CERTIFICATE OF APPROPRIATENESS

Property: 2009 Decatur Street, Tracts 8 and 9a, Block 417, Baker W R NSBB Subdivision. The property includes a noncontributing one story commercial structure situated on a 4,500 square foot (45' x 100') interior lot.

Proposal: New Construction – Revision of a COA granted for a single family residence in July 17, 2014. Approved design featured reusing a 24' deep section of CMU wall from the non-contributing building that previously occupied the site. This wall collapsed when the builder attempted to remove the remainder of the structure.

WEST SIDE ELEVATION

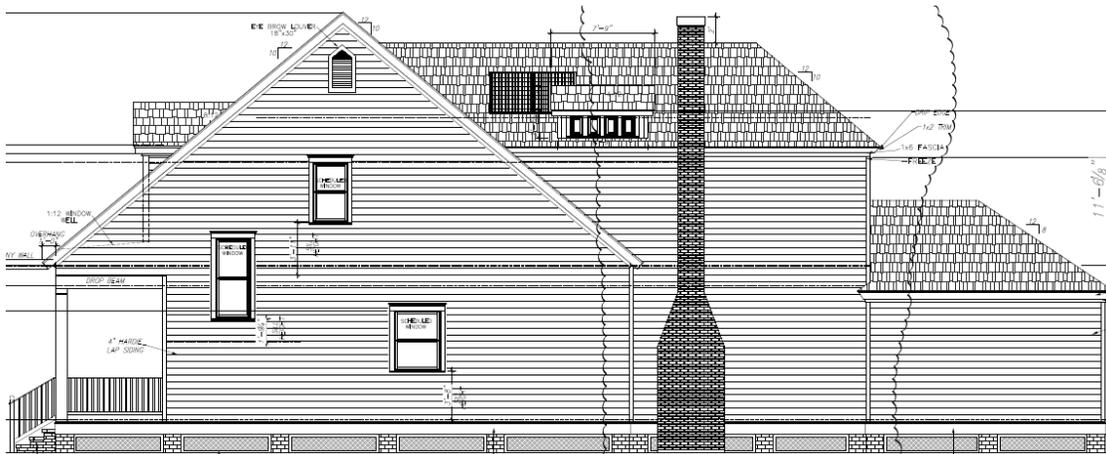
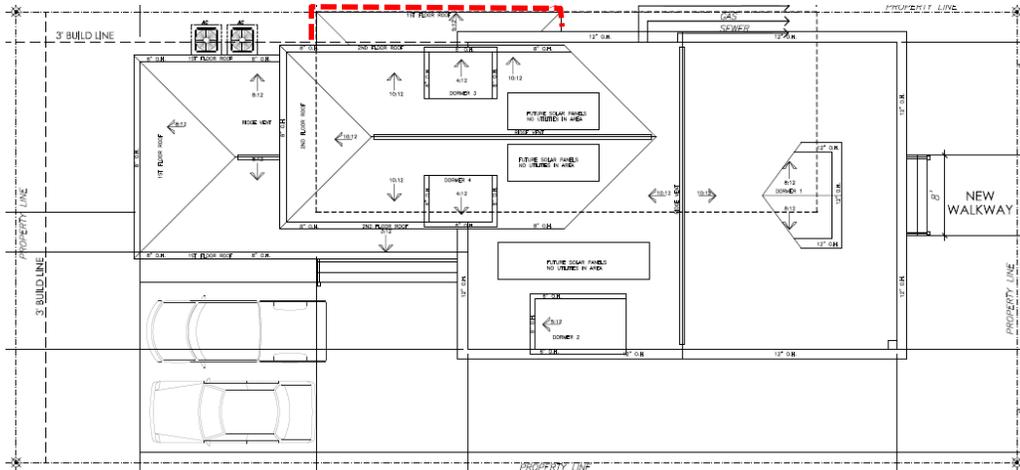
- Omit incorporation of the CMU wall and use wood framed cementitious clad wall material.
- Add a brick chimney to the west elevation.

Side Elevation: ***Previously Proposed** The proposed house will consist of three massing volumes when viewed (West) from each side elevation (from front to back): A two story section topped with a side gable roof, a two story section with a hipped roof, and a one story section with a hipped roof. The side facing roof gable will start at the front porch eave, 13' from grade, and slope upward to a peak ridge of 33'. The front volume of the house will feature a window on the first floor, one on the second, and one in between to provide light to a stairwell. The middle section will be inset 1' from the side facing gable and feature a portion of reclaimed CMU wall from the noncontributing existing storefront proposed to be demolished. The third volume will be inset 1' from the second volume.*

Revision: The proposed CMU wall has been omitted.

SITE PLAN
APPROVED 7/17/14

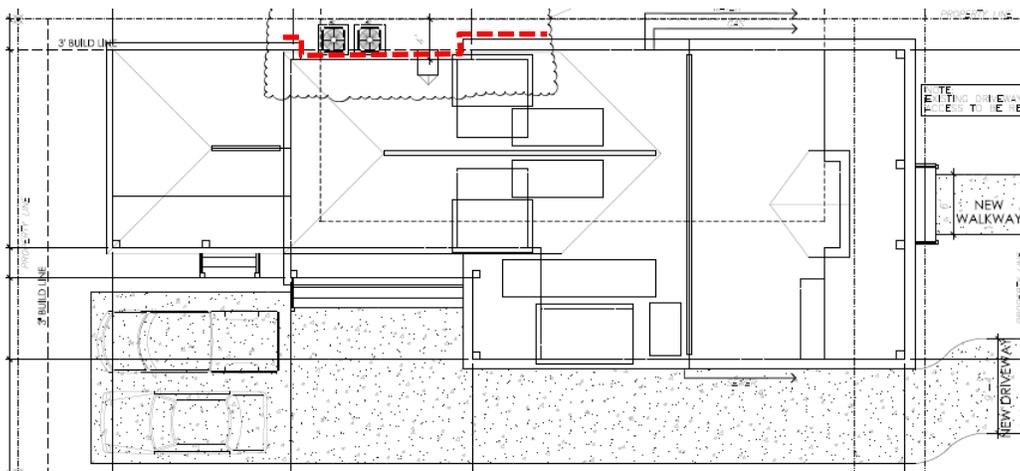
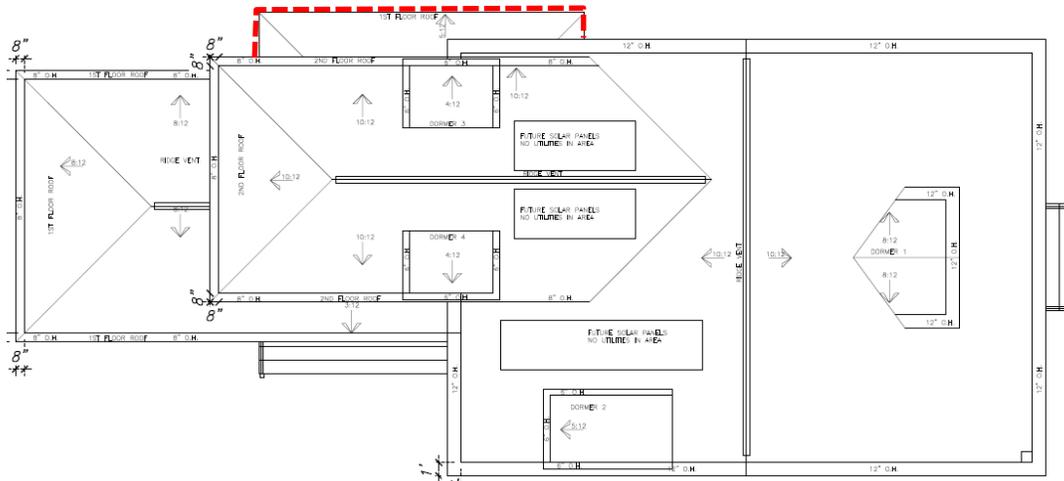
Revision: Replace the CMU wall with a wood framed wall with cementitious siding. Previous CMU wall was situated directly on the west side property line. The new section of wall will be built within 4' of this property line. This will be inset from the front portion of the house, which is setback 3'.

FIRST FLOOR PLAN

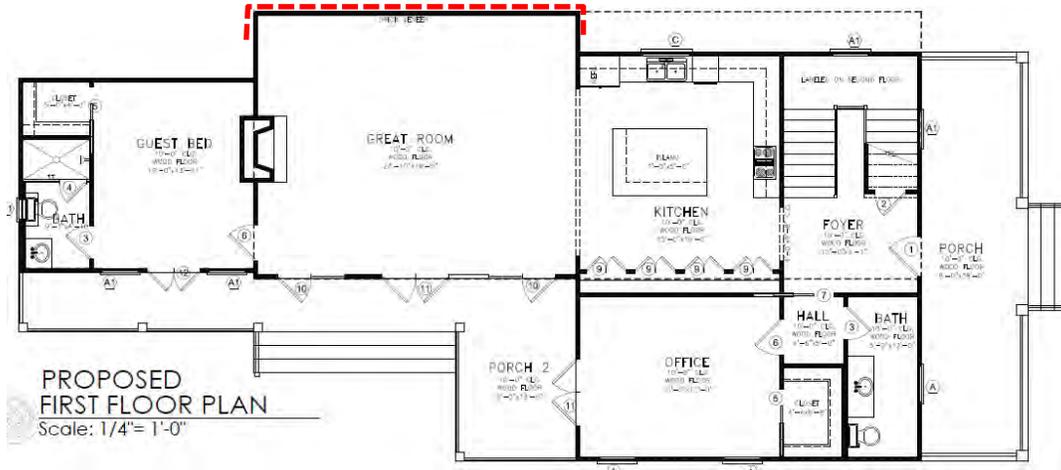
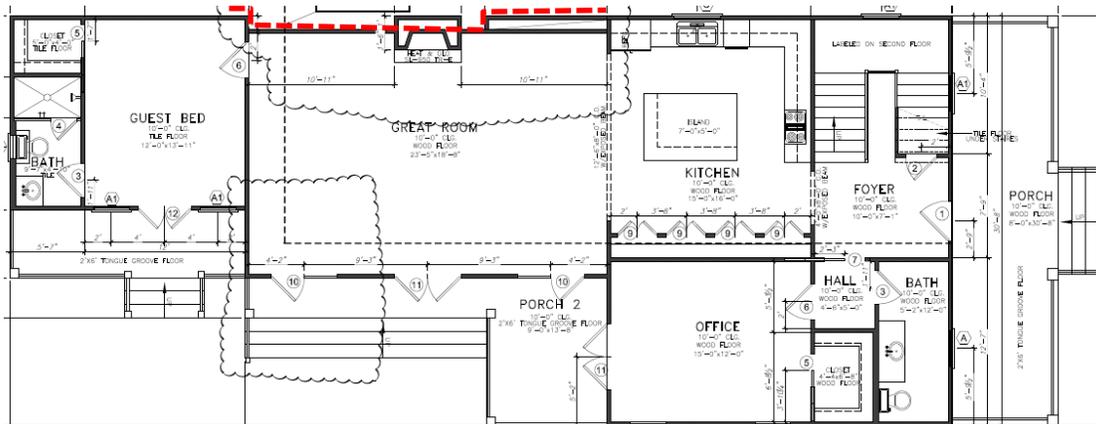
Exterior Materials: ***Previously Proposed** The proposed residence will have 4" horizontal lap cementitious siding. A 10' tall by 24' deep portion of the noncontributing existing building's CMU wall will be incorporated into the west wall of the proposed residence. The height of the wall will be increased by 2' by adding four rows of new CMU blocks and will feature a 5-over-12 hipped roof.*
